**CITY OF PORTLAND, MAINE**  
**HISTORIC PRESERVATION BOARD**

**PUBLIC HEARING  
FORT SCAMMELL, HOUSE ISLAND**

**TO:** Chair Sheridan and Members of the Historic Preservation Board  
**FROM:** Deborah Andrews, Historic Preservation Program Manager  
**DATE:** February 15, 2018  
**RE:** February 21, 2018 – **Public Hearing**

Application for: Certificate of Appropriateness for Campground Development,  
including installation of Temporary and Permanent Structures

# H6 Utility/Operations Shed

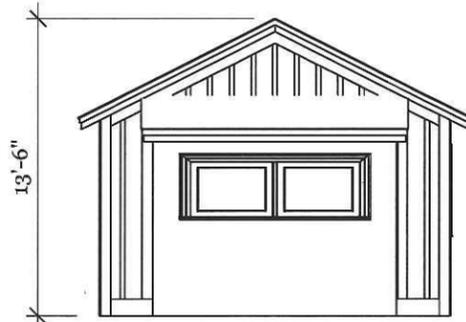
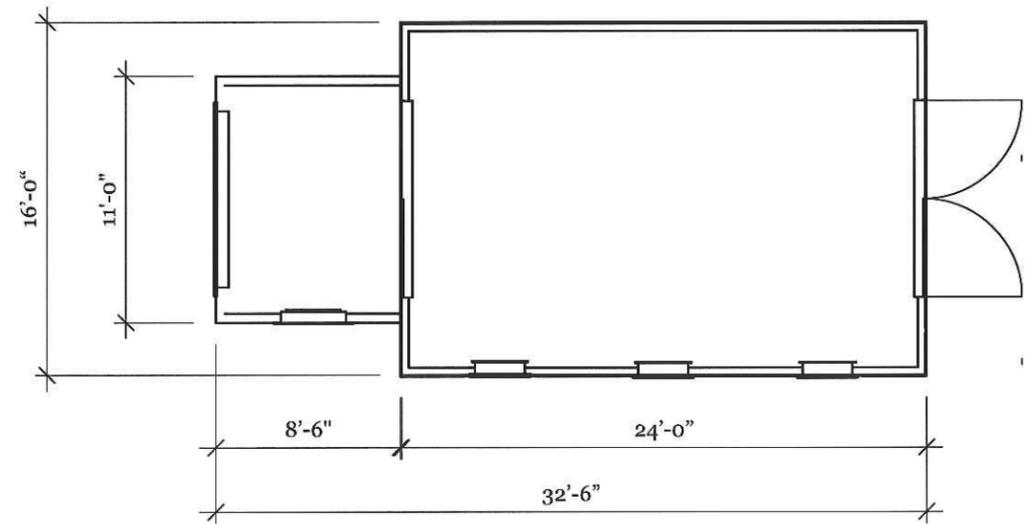
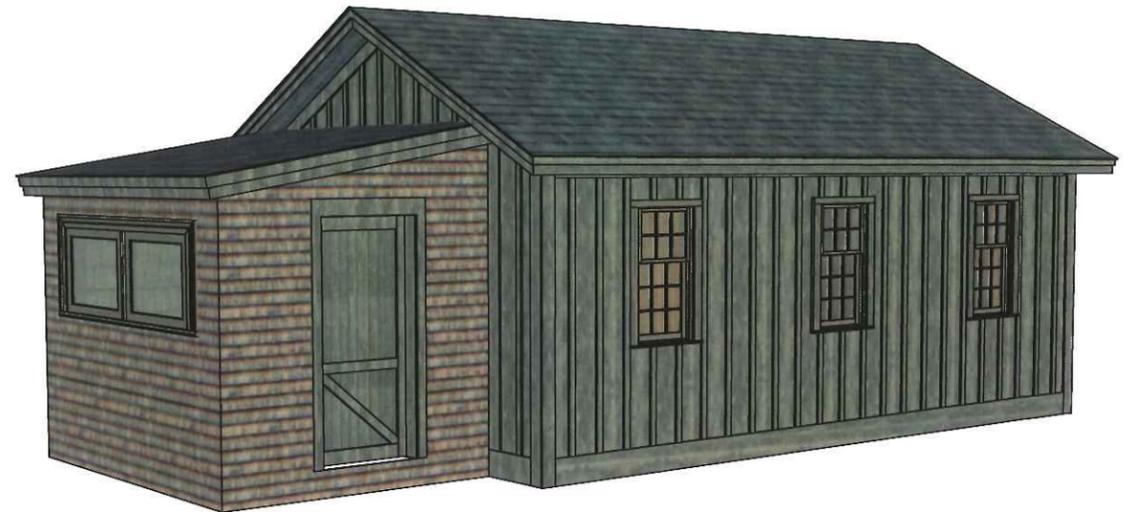
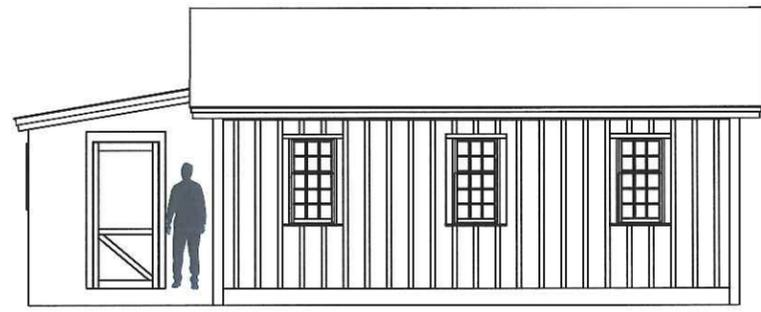
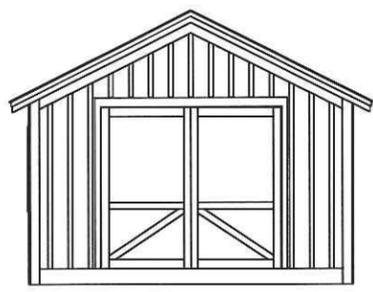
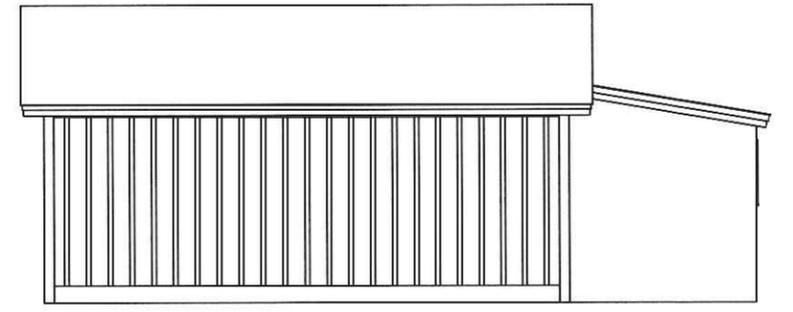
- \* Material Specifications for Accessory Structures. Questions were raised about the asphalt roofing proposed for the bathroom and shed structures. In order to provide a monolithic, recessive appearance, it was suggested that a wood shingle roof be considered. Also, Board members suggested that the clad windows be ordered in a color close to weathered wood.

**PROPOSED DECK  
PLAN - REVISED**

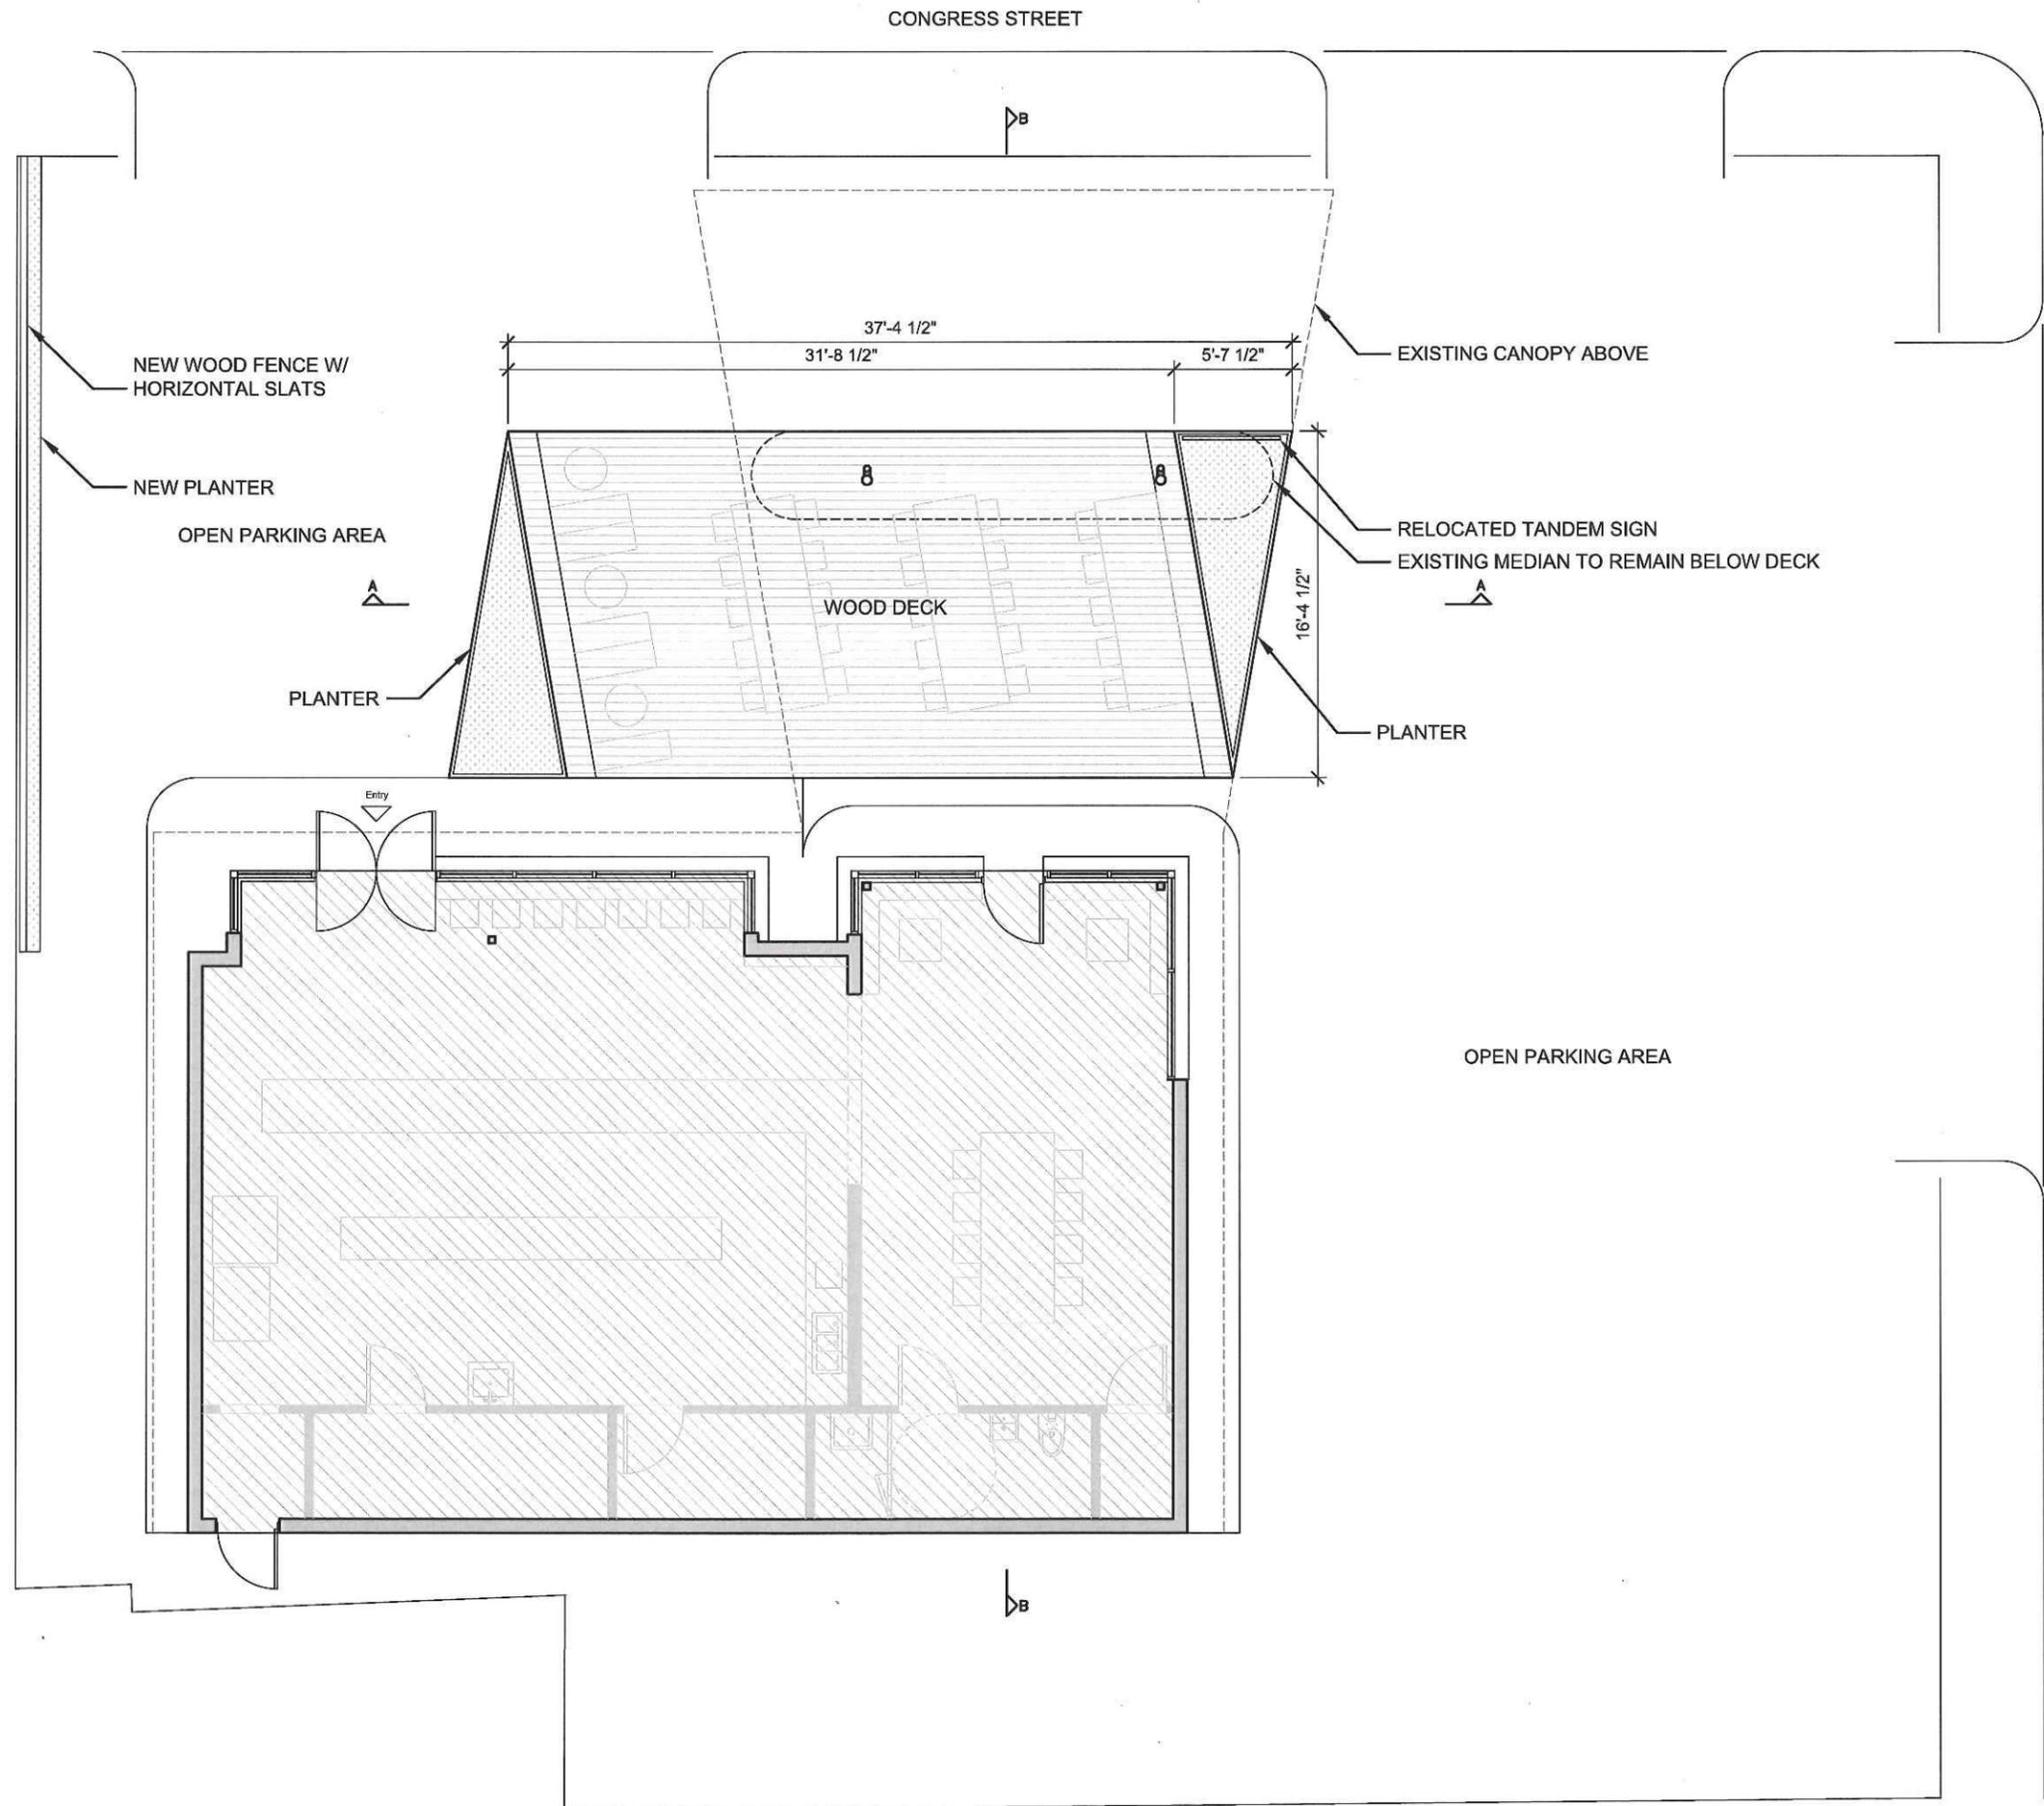
Mr. Pratt’s proposed deck is a parallelogram approximately 37’ by 16’, partially underneath the existing canopy. It would begin flush at the sidewalk immediately in front of the café entrance wall, and will be approximately 10” – 12” above the pavement at the front where the grade is slightly lower. The deck framing will completely cover the gas pump island. At that height a long step parallel to Congress Street will be necessary for access from the front. Mr. Pratt points out that the deck will be reversible; it is unclear to staff whether any anchoring to the pavement or island is planned.

Large triangular planters would block off the east and west ends of the deck; the lower planter at the west end (right side, as viewed from Congress Street,) incorporates bench seating 16” off the deck. The eastern planter facing Carleton Street is shown on the plans as 36” high. Mr. Pratt told staff he envisions the faces of the planters, fence, and deck framing as horizontal cedar boards, finished naturally.

The height of the proposed fence on the western boundary is not noted on the plans, though Mr. Pratt told staff it would be approximately 24” – 30” high, enough to hide the guardrail and provide a low barrier from the neighboring gas station. He intends to employ the same aesthetic for the fence as with the deck and planters – natural cedar boards. (Note the staff photo of the property – Attachment 4, in which small natural wood planters are visible next to the tables under the canopy.)

**PROPOSED DECK - REVISED  
SECTIONS & ELEVATION**

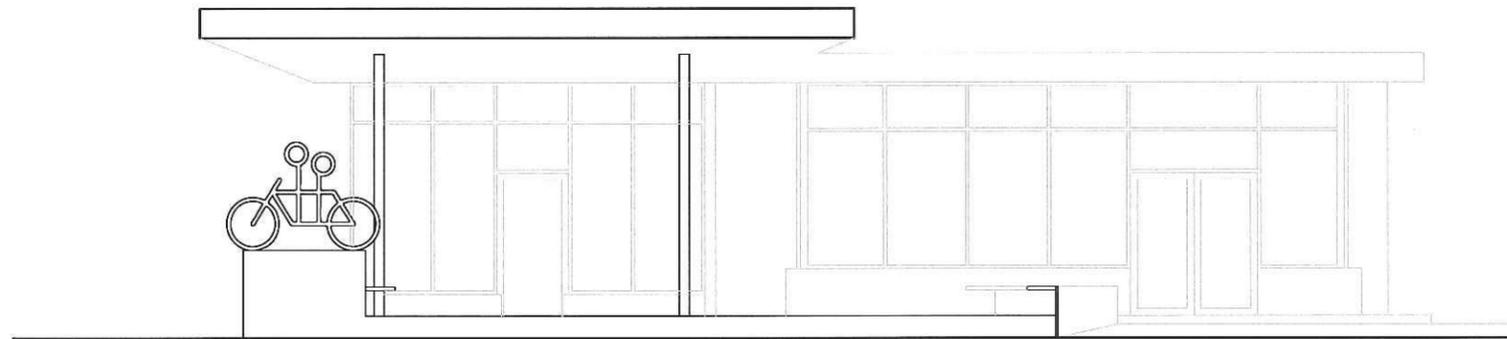
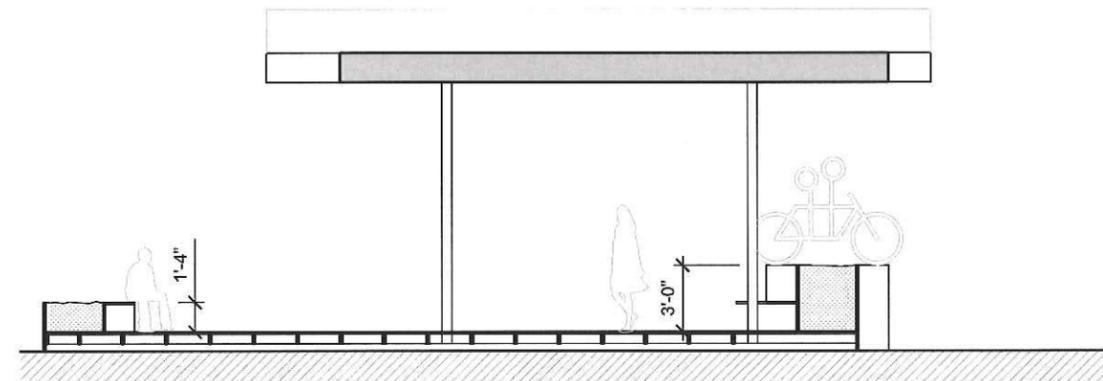
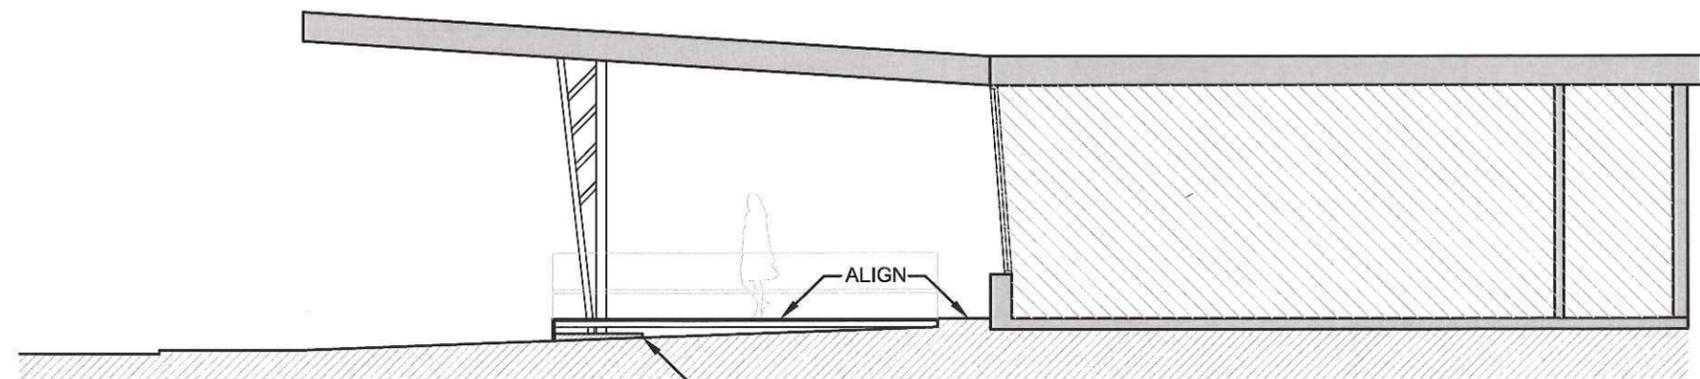
- Staff understands the warmth of natural wood might lend a soft allure to the seating area, but could a soft colored stain blend better with the service station aesthetic?
- The choice of wood for the deck, seating, and planters will attract human activity, but perhaps the fence at the west side of the lot needn't follow the same pattern. Could a more commercial aesthetic – perhaps metal slats – be installed there, still providing an attractive divider and screen for the guardrail, but fitting with the nature of the original property?
- Staff realizes the benefit of the barrier provided by the 36" high planter on the east (Carleton Street) side, but suggests experimenting with a somewhat lower planter, to see if a lower wall there would suffice.
